Environmental Review Team Report

Quanaduck Cove
Stonington, Connecticut

July 1980

FLOOD HAZARD AREAS

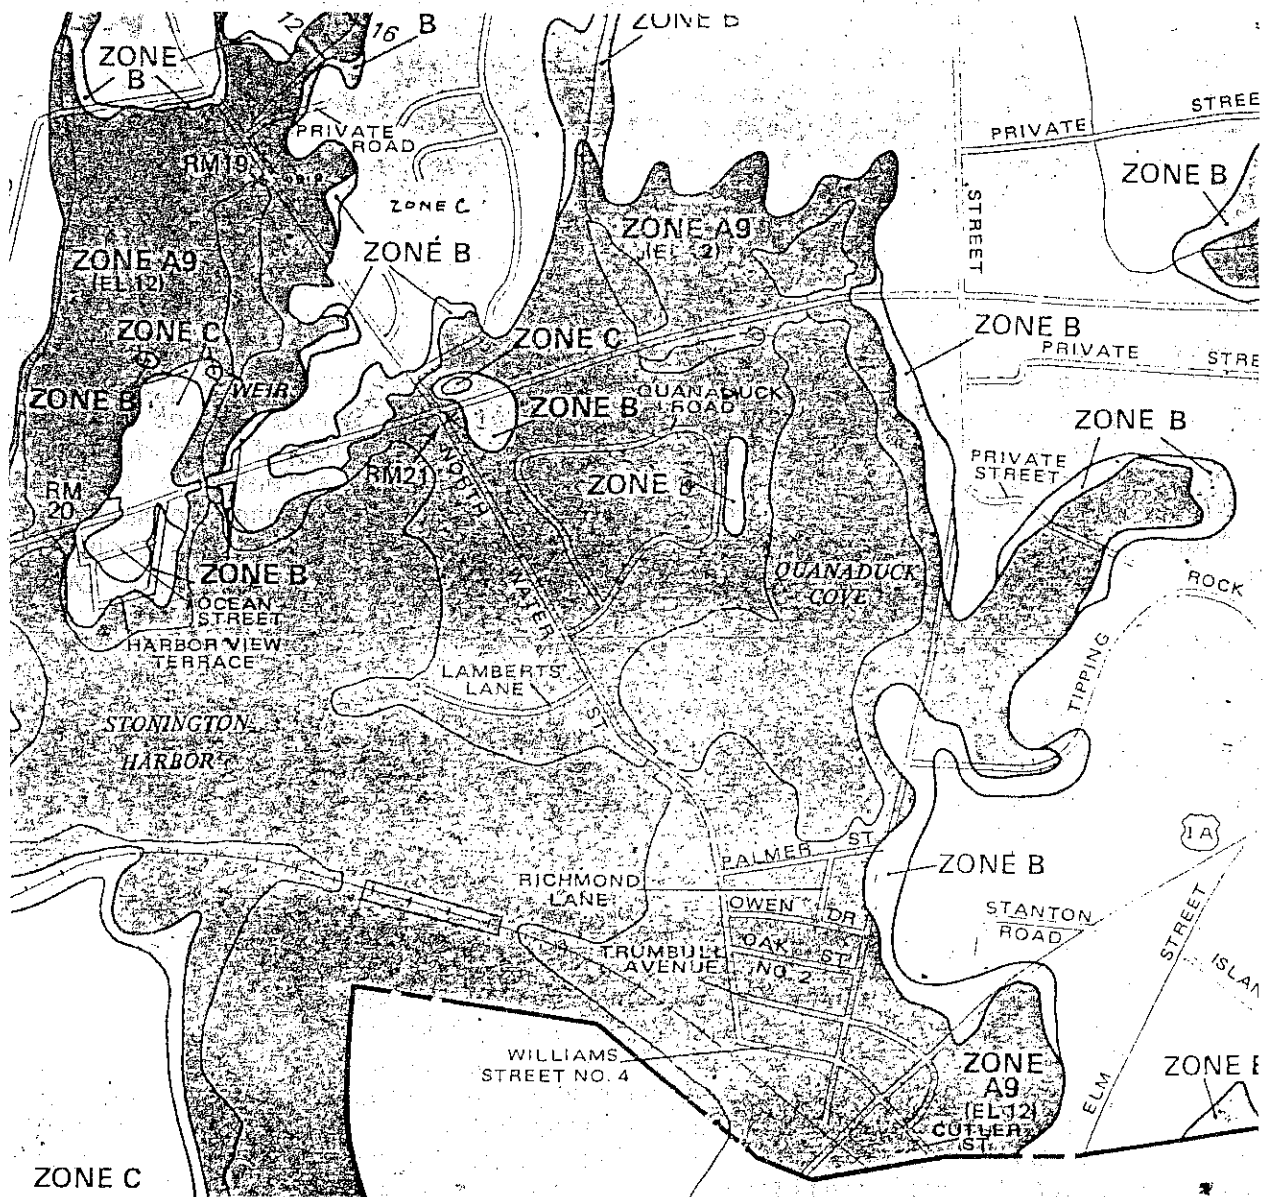
The most recent flood-hazard study of Stonington, which was released by the U.S. Department of Housing and Urban Development, Federal Insurance Administration, indicates that all but a small section in the northwestern corner of the site would be subject to inundation by the 100-year flood. The estimated flood elevation would be about 12 feet. For the 50-year and 10-year floods, water elevations are estimated at approximately 10 feet and 7 feet, respectively. The first-floor elevations of all structures presently planned are higher than any of the designated flood heights. Basement levels for all buildings are lower than any of the designated flood heights, so that structural floodproofing would be required (the high groundwater levels in themselves warrant special precautions for basements). The proposed parking lots and garage floors are lower than the 100-year and 50-year flood elevations and would therefore be inundated by those events. Much of the new road would also be flooded by these events, and a small section of road near the westernmost storm drainage outlet to Quana Duck Cove would be affected by the 10-year flood. The latter section of road probably should be replanned to have an elevation that is at least greater than the 10-year flood height, since such a flood has a significant probability of occurrence (10 percent) in any given year.

Consideration should be given to whether the catch basins are designed sufficiently to prevent surface ponding during times when the inlets to the drainage pipes are submerged. Many of the invert elevations are low enough (5.5 feet or less) to allow total submergence by coastal backwaters during a 10-year flood. The basins may then fill up with runoff unless enough hydraulic head can be achieved to allow water to pass through the drainage system faster than it is entering the catch basins.

The proposed project site lies within the A Zone on the Flood Insurance Rate Map. Within this area all new buildings must have their first floors, including basements, elevated above the level of the 100-year flood. The first floors of buildings proposed at the eastern end of the site appear to be well below the required elevation. Extra care must be taken to insure that water supply systems in this area are built to prevent infiltration of flood waters. Sewer lines should also be constructed to prevent pollution of flood waters. The proposed density of the development obviously argues against the use of on-site subsurface disposal for sewage. It should also be recognized that a 100-year storm would cover the proposed driveways on the site with as much as five feet of flood water.

COASTAL RESOURCES

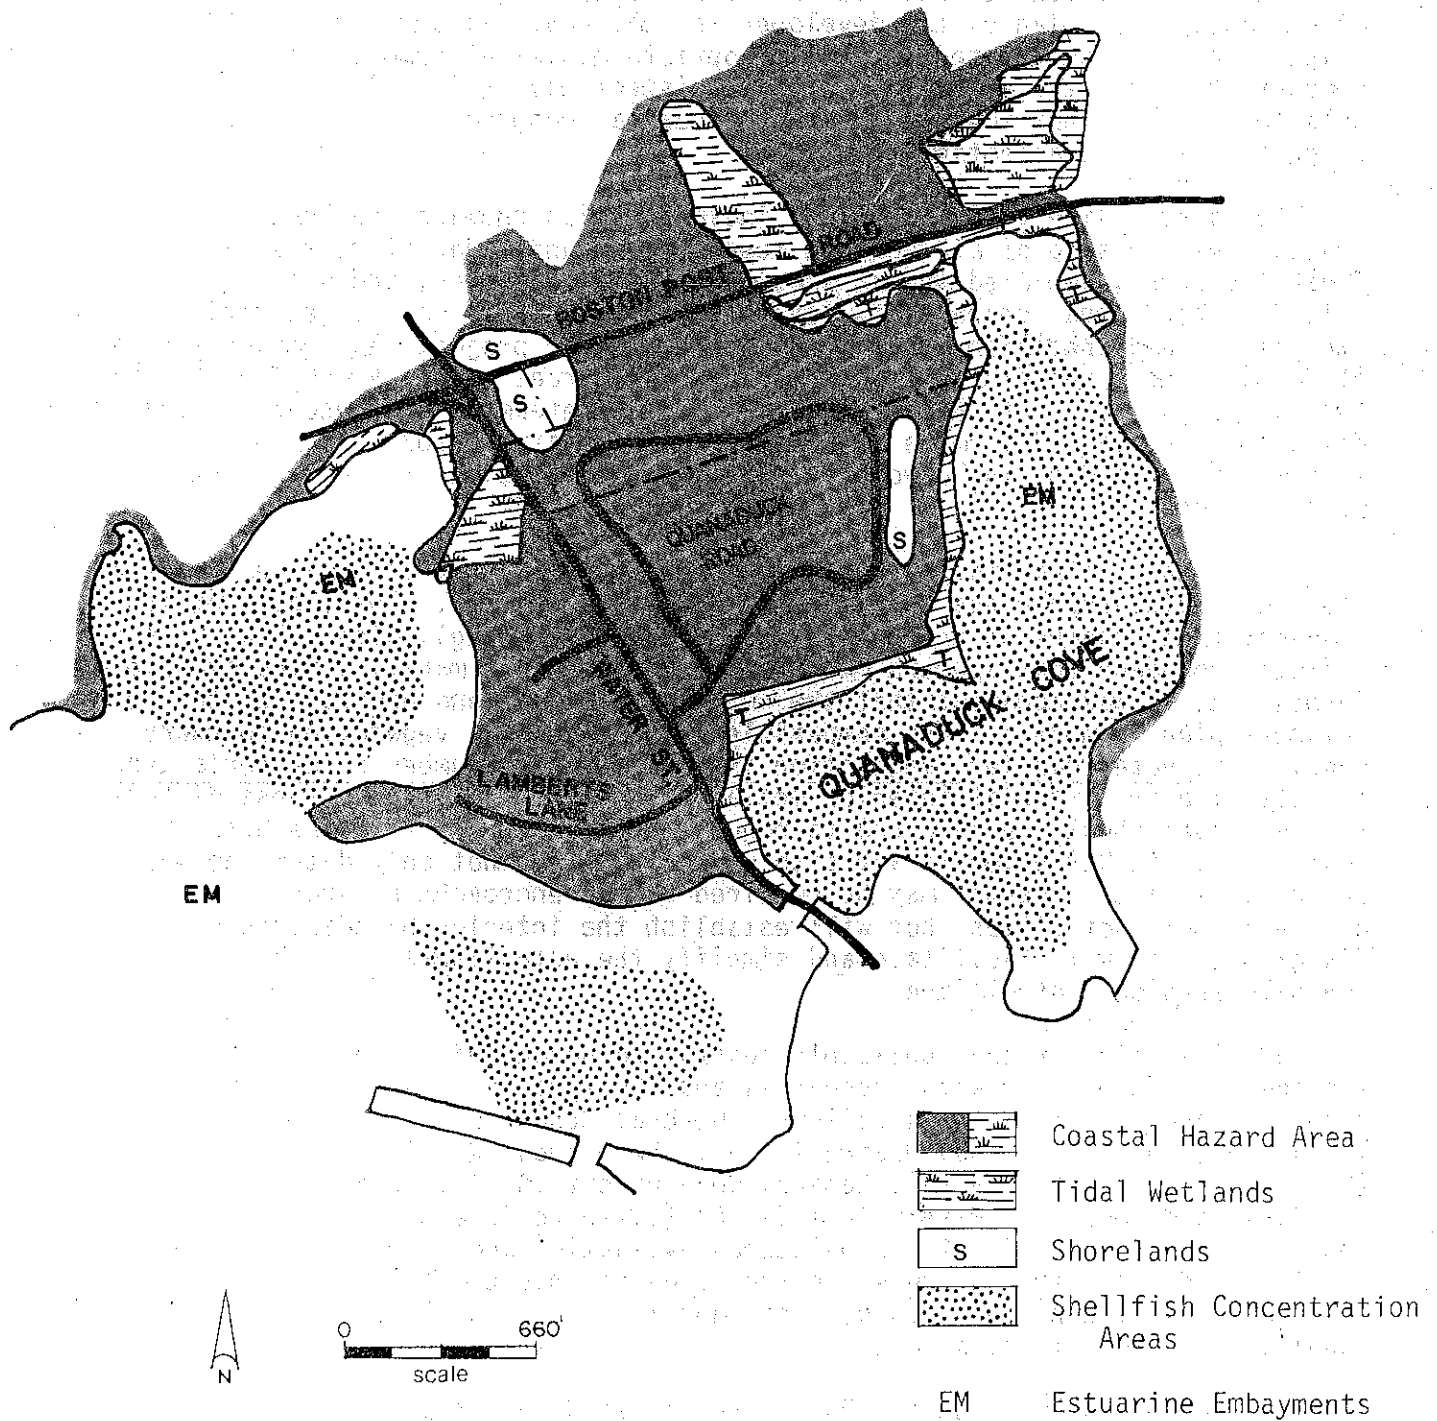
The coastal site plan must first include a plan showing the location and spatial relationship of all coastal resources on and adjacent to the site. These resources, depicted in the accompanying illustration, include coastal (flood) hazard area, shorelands, tidal wetlands, coastal waters (estuarine embayments) and shellfish concentration areas. For projects as complex as this, it would be most beneficial to depict these resources on the same plan illustrating the various elements of the project in order to determine the resource location of all subelements and determine their impacts on coastal resources. In addition information should be included that identifies the design, timing and methods of construction.

One of the central issues here, is the location of the condominium units and stormwater discharge pipes in regard to the tidal wetland. The tidal wetland boundary that appears on the developers' plan is strikingly dissimilar to the official boundary that appears on state's tidal wetland maps. During the field inspection, it was apparent that the interior tidal wetland boundary on the developers plan is more or less compatible with the actual vegetation boundary. However, as noted earlier, vegetation is only one of a number of criteria used to determine the official interior wetland boundary. To resolve these differences, the developer should be required to request a field survey from the Water Resources Unit in DEP prior to any site work. This will not only determine whether or not a regulatory permit may be required due to encroachment upon the wetland by one or more activities, but will establish the interior boundary through flagging. This will facilitate and simplify the establishment of the staked hay bale erosion control line.
